CITY PLANNING DEPARTMENT

Memorandum – FINAL

To: City Plan Commission
From: Jonas U. Bruggemann, MSCRP | Senior Planner
Date: December 31, 2024 (revised 1/3/2025)
RE: Warren Avenue – Assessors Plat 18-4, Lot 714
 “Calise Development LLC Plat” – Residential Planned District: Preliminary Plan

Proposed Plan

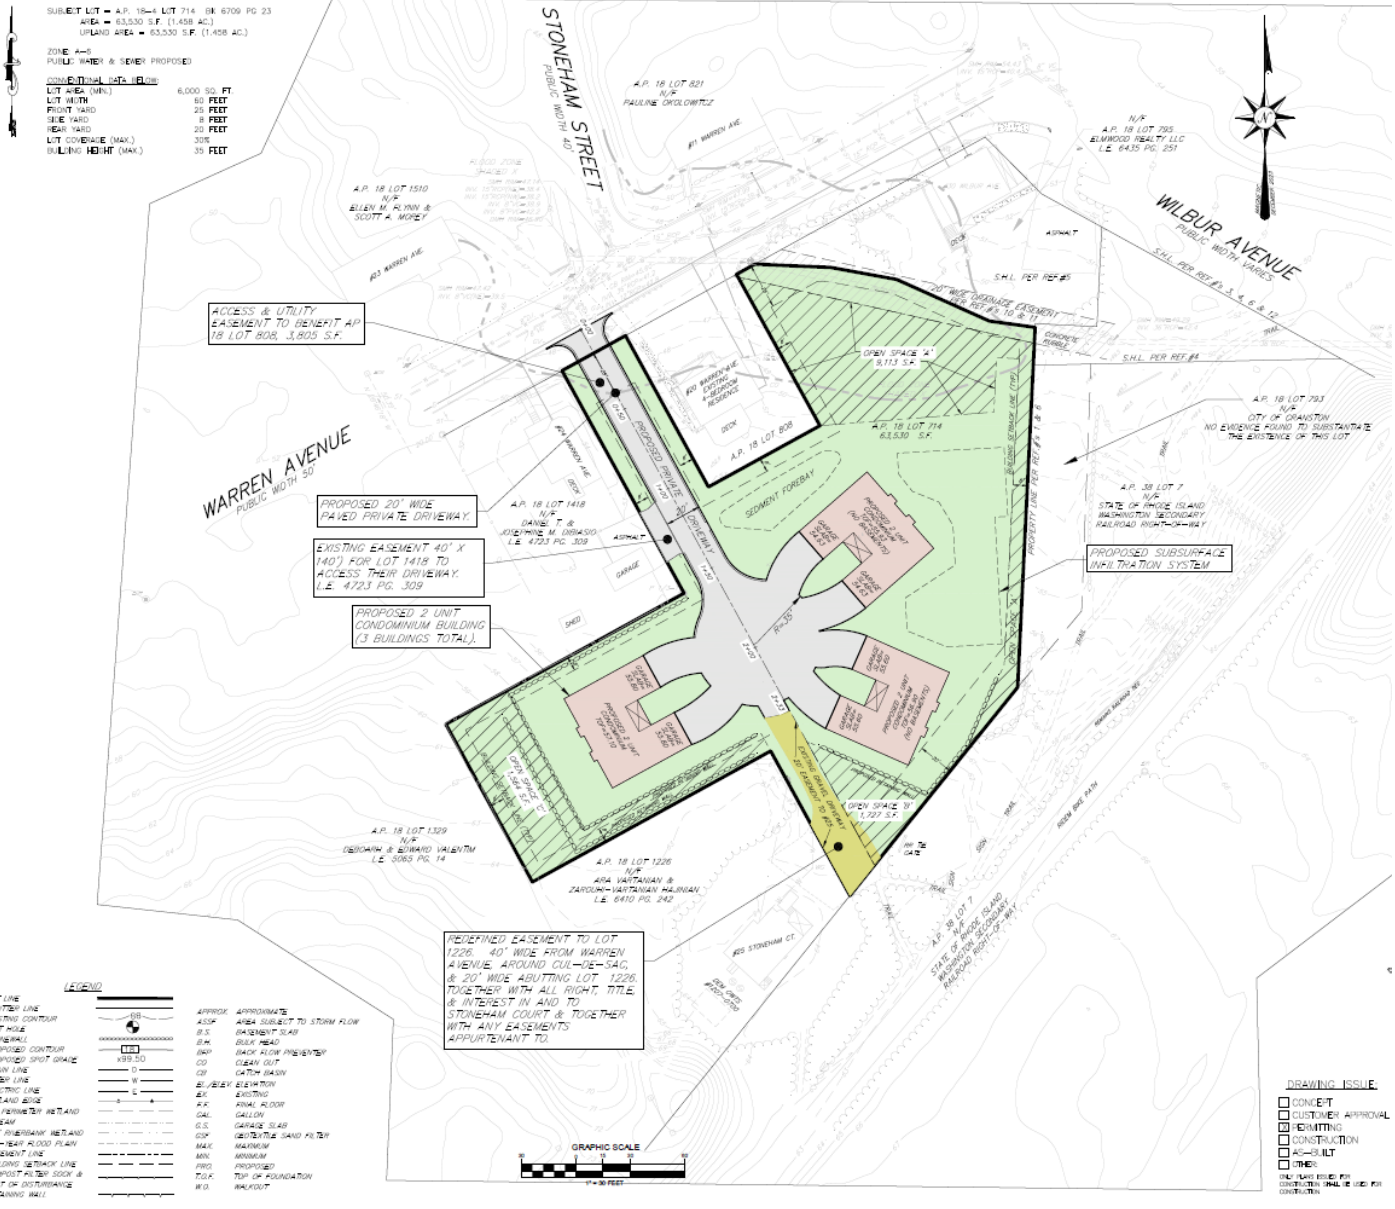
- b. Traffic Safety Division: Mr. Steven Mulcahy has reviewed the Proposal and mentioned that the applicant must work with the Tax Assessor, the Fire Department, and the Department of Public Works to develop a proper address for the site to avoid confusion with the nearby Stoneham Street.

- c. Sewer Division: Mr. Edward Tally, Environmental Program Manager, forwarded an Availability of Sewer Service Letter from Veolia Water on August 30, 2024 which states that a 15" RCP sewer is available within Warren Avenue and a new sewer service lateral will be required if this development moves forward. Due to the proposal of a sewer main extension along Stoneham Court, Tally requested that the Applicant apply to DPW for sewer design review. The applicant has submitted the requested application and it is currently undergoing review. Final approval of the sewer design will be required prior to application for Final Plan review.

- d. Kent County Water Authority: The Applicant has provided a Water Availability Letter from KCWA which confirms the existence of a 6-inch Ductile Iron stub of water main heading down Stoneham Court.

3. Fire Department: Mr. James Woyciechowski, Fire Marshal has reviewed the Proposal and approved of the proposed location of the fire hydrant.

- Each unit will provide a two-car garage with two additional spaces in the unit driveway in front of the garage leading to a total of four off-street parking spaces per unit, thereby far exceeding the off-street parking requirements.
- The proposed cul-de-sac provides the minimum required radius of 35'.
- The 20' wide driveway adheres to the minimum requirements and provides adequate width for two vehicles to pass each other and for emergency vehicles to enter the site.
- The addition of six housing units should only create a minimal impact on the surrounding traffic circulation.

- Access to the site will be achieved via an existing private driveway (Stoneham Court) which is proposed to receive a 20ft wide paved road. Access to 25 Stoneham Court at the rear of the property is to be maintained via a 20ft wide unpaved right-of-way via a permanent access easement.
- Access to rear parking lots for 20 and 24 Warren Avenue have been provided through permanent easements. The Final Plan shall depict the access point to the rear parking lot of 20 Warren Avenue.
- Upon review of the Fire Marshal, no issues for emergency vehicle access have been found.

1. All outside approvals from relevant state and local agencies shall be provided, in particular a letter of approval from the Department of Public Works for the sewer design plan and written approval from the Cranston Fire Department and Kent County Water Supply Board of the design and location of the proposed fire hydrant.
2. The access easement for 20 Warren Avenue and the grading of said property's driveway must be depicted on the Final Plan.
3. Curb-to-curb pavement restoration shall occur as needed in accordance with and to the satisfaction of the Department of Public Works.
4. Payment of the Eastern Cranston Capital Facilities Development Impact Fee of \$3560.76.
